Appeal of Cherokee Triangle Architectural Review Committee Decision Regarding 2213 Patterson Avenue

DESIGN SERVICES 16COA 1055

Exhibit C - Height of Various Walls

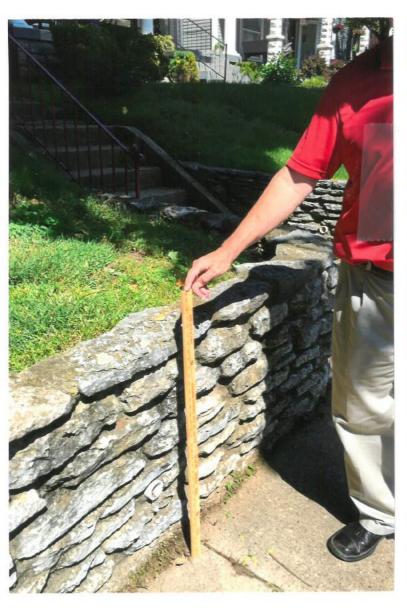
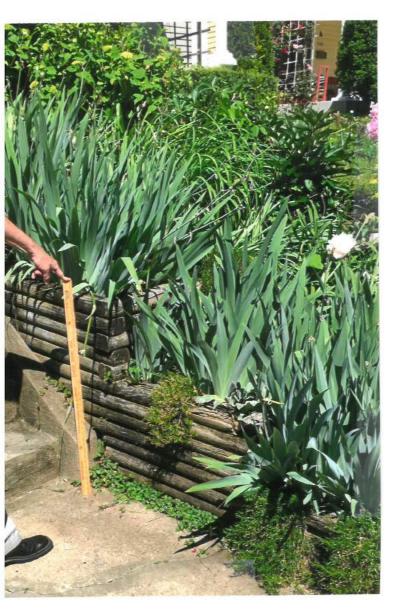
The first photograph (Exhibit C) reflects the height of various walls within that square block. The walls were as tall as 40 inches in the same square block. Exhibit D also reflects the various building materials used for the construction of walls within that square block. These photographs reflect that the height of the retaining walls and the materials used vary greatly. There is nothing about this particular wall that suggests that it be torn down when compared to similar walls located nearby.
